AERONAUTICAL CHARTING MEETING
Instrument Procedures Group
Meeting 22-01 – April 25-26, 2022

FAA Control # 22-01-365

Subject: As Charted, Teardrop Course Reversals Lack Pilot Guidance on How to Fly the Reversal

Here is a teardrop course reversal (excerpted from GUP LOC 6, Appendix A has full procedure):

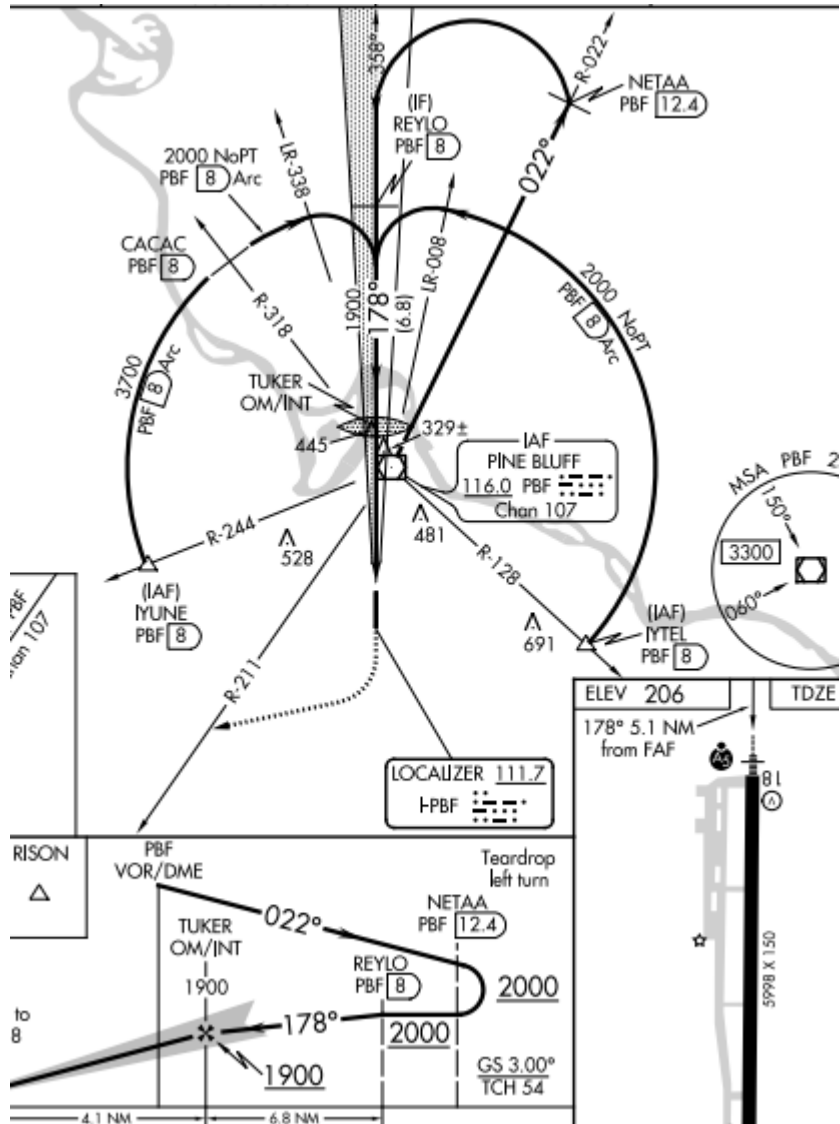
The FAA publishes extensive pilot guidance on other course reversals; namely procedure turn, hold-in-lieu of procedure turn, and DME arcs. However, there is no substantial guidance on how to fly a teardrop. Ask most pilots “how to” and they will respond, “standard rate turn,” which is incorrect.

When Teardrops are presented by a FMS, depending on ARINC 424 coding and the display software, the Teardrop may be shown like the as-charted, as a 90-degree intercept, or a sharp 180-degree turn.

If charting continues to depict Teardrops as semicircles, provide pilots with AIM and/or IPH guidance equivalent to procedure turn, hold-in-lieu of procedure turn, and DME arcs.

Alternatively, change procedure design and/or charting to provide a navigable route line.

ILS or LOC RWY 18

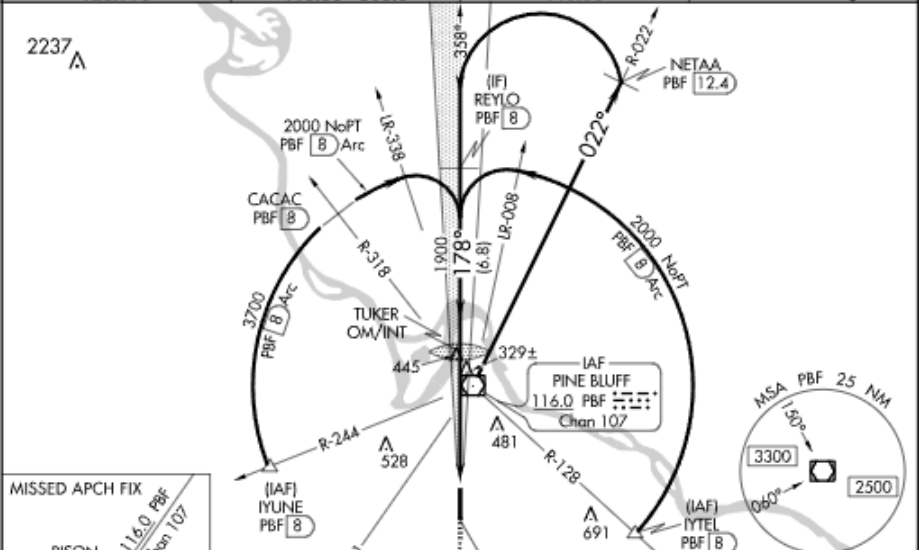
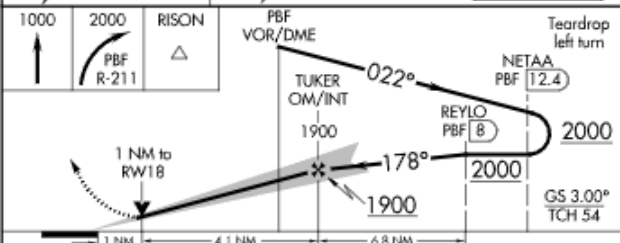
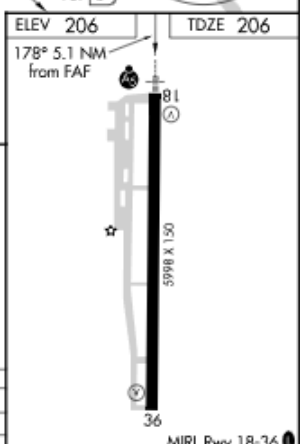
Problems may result from lack of guidance; for example, in PBF (full chart in Appendix A), there is no profile view “remain within” distance note for the teardrop. Without this note, the turn from NETAA to intercept the final is technically unbounded as there is no way to follow the depicted semicircle (when flying the approach with conventional navigation).
